**Subject: Bid Package #2**  
Abbott Middle School HVAC Replcmt-DSA 01-119556  
George Hall Elementary School HVAC Replcmt-DSA 01 119523  
Laurel Elementary School HVAC Replcmt DSA 01-119551  
**San Mateo - Foster City School District**

**ADDENDUM NO. 1**

**Subject:** Abbott Middle School HVAC Replacement  
San Mateo - Foster City School District  
Aedis Project No. 2021005.06  
DSA Application #01-119556

### ADDENDUM NO. 1

DATE **11/24/2021**  
 JOB # **2021005.02**  
 SHEET # **AD-1  
 E3.2**

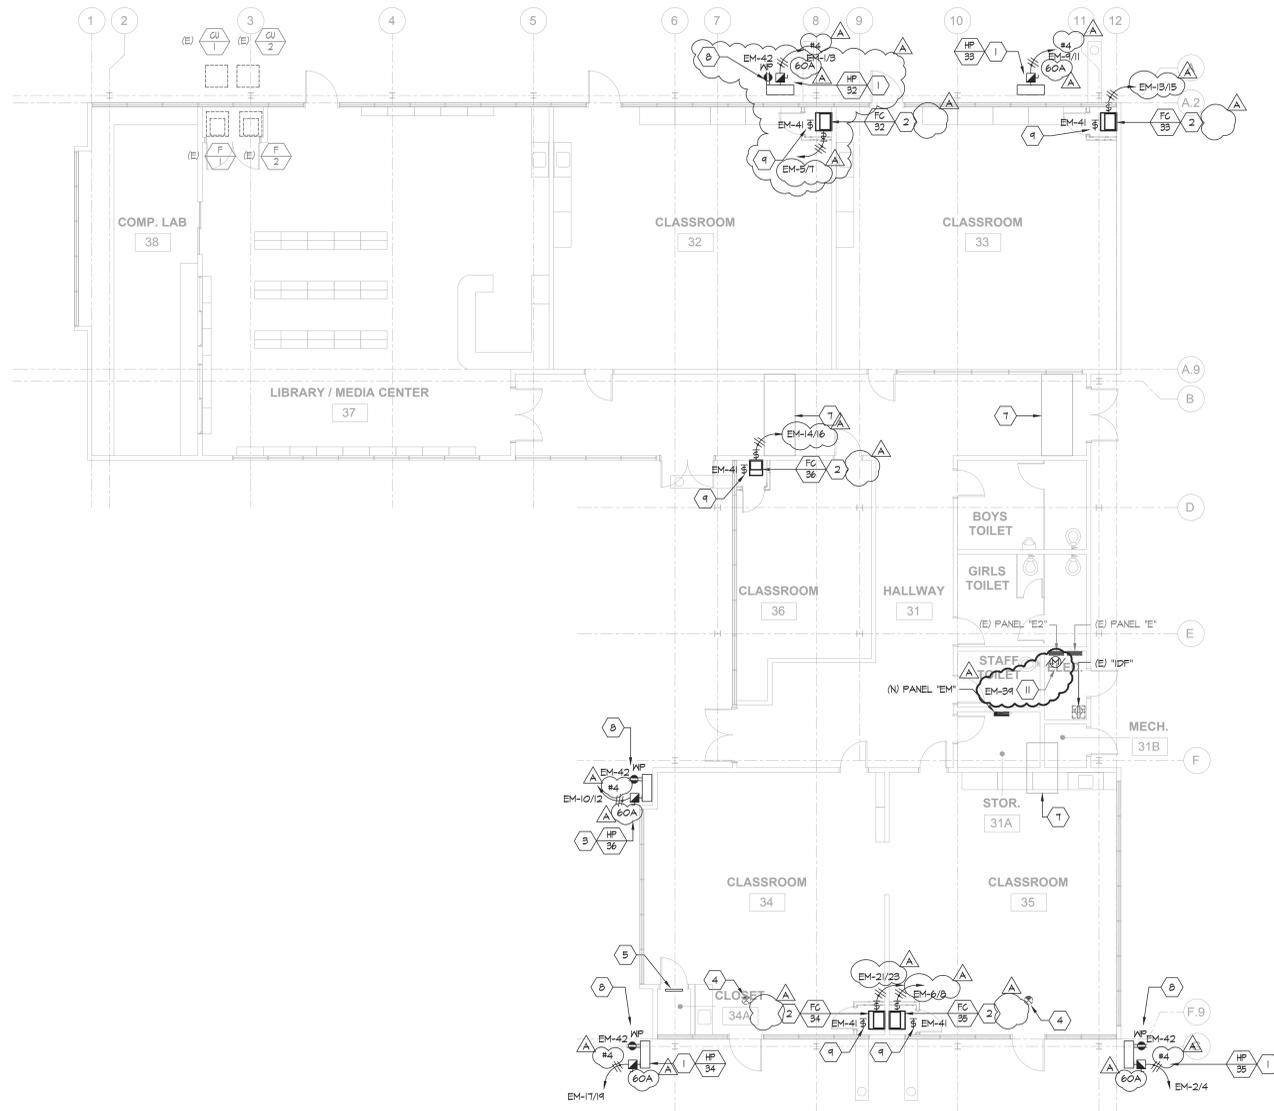
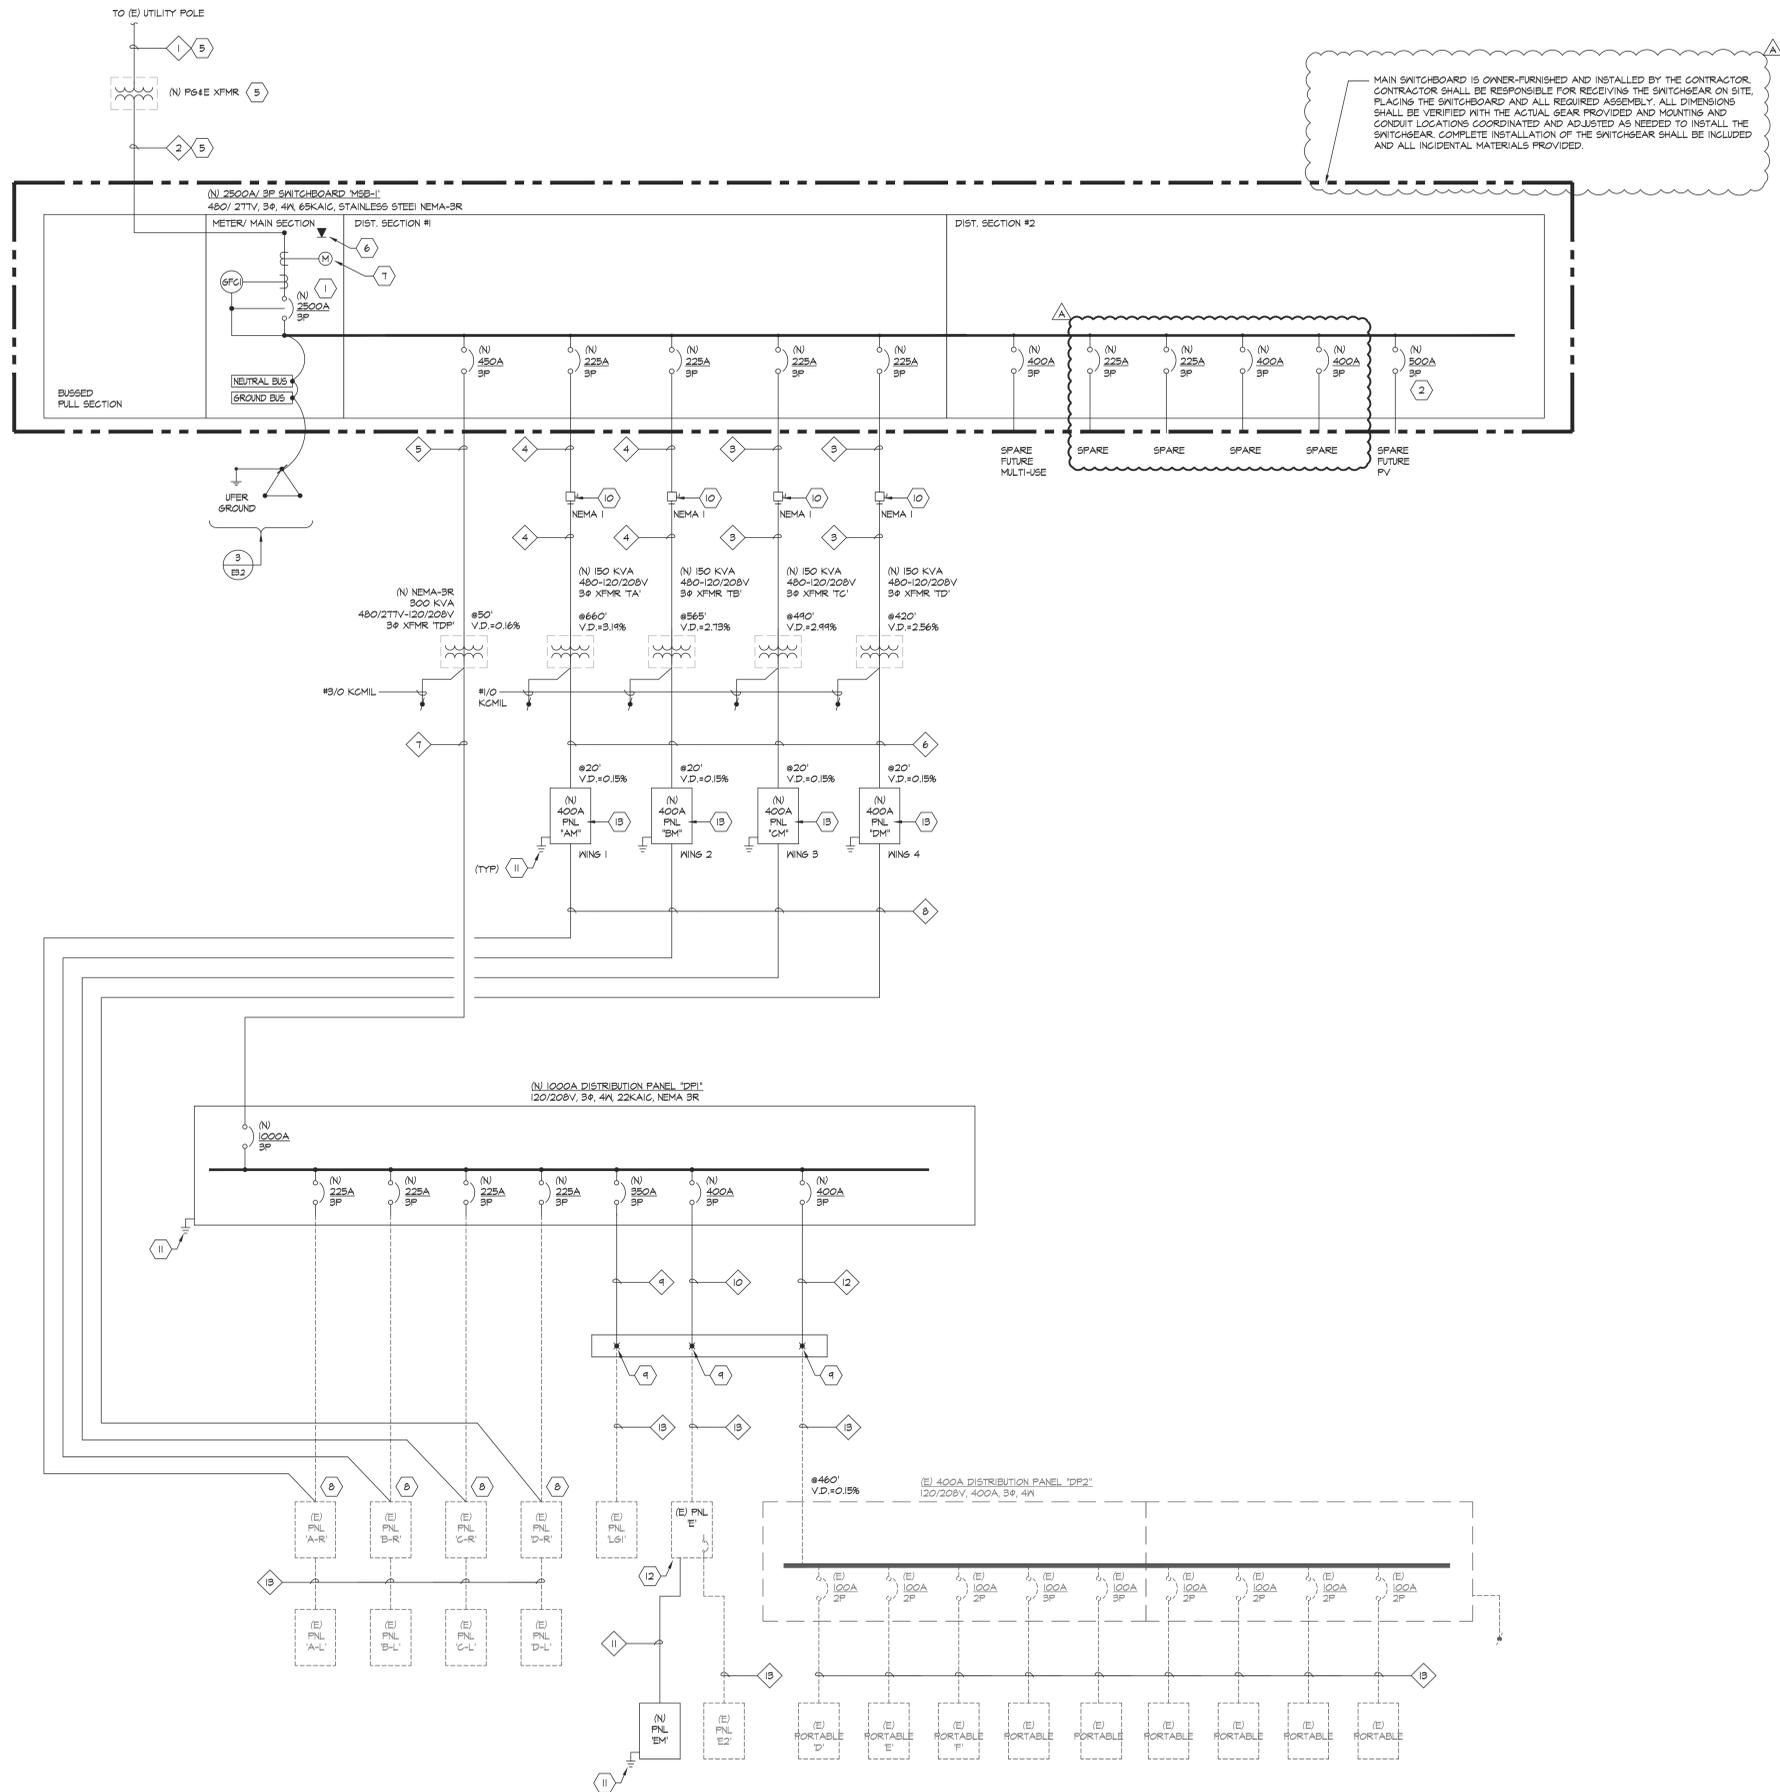
ITEM NO. 1.20: DRAWING SHEET E3.2 – ELECTRICAL DEMO FLOOR PLANS, ESCALON

Revise: Electrical plan 1/E3.2 per AD1-E3.2

Add: Power for exhaust fan at building per AD1-E3.2

Add: General Note #6 per AD1-E3.2

Revise: Sheet Note #5 per AD1-E3.2

Omit: Sheet Note #10 per AD1-E3.2

Add: Sheet Note 11 per AD1-E3.2

Revise: Location of HP-2 per AD1-E3.2
